To: Amanda Seraglio
PO Box 21, Fairfield NSW 1860
Project/File: 15 Hilwa Street and 896 to 898
Woodville Road, Villawood

The following memorandum comprise a summary of Stantec's review of the response to Transport Impact Assessment Review for a planning proposal application comprising a mixed-use development at 15 Hilwa Street and 896-898 Woodville Road, Villawood, prepared by Genesis Traffic.

Reference: Planning Proposal Woodville Road and Hilwa Street, Villawood

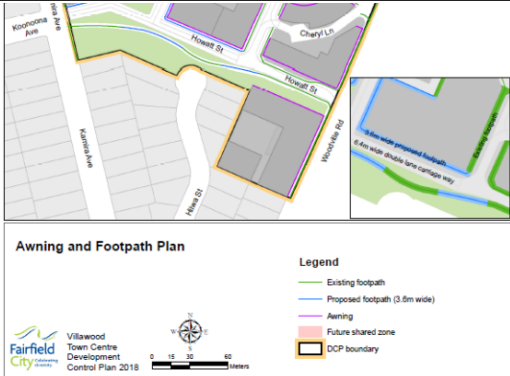
7.	Footpath/ Shared Path	<p>The reviewer notes there are no details on any proposed footpaths connecting to existing facilities and/ or aligning with requirements set out in Figure 9 of the Villawood Town Centre DCP 2020, extracted below.</p>	Moderate

Item	Section	Comment	Priority
		 <p>It is recommended that the indicative development scheme is updated to provide details on the proposed active transport connections.</p>
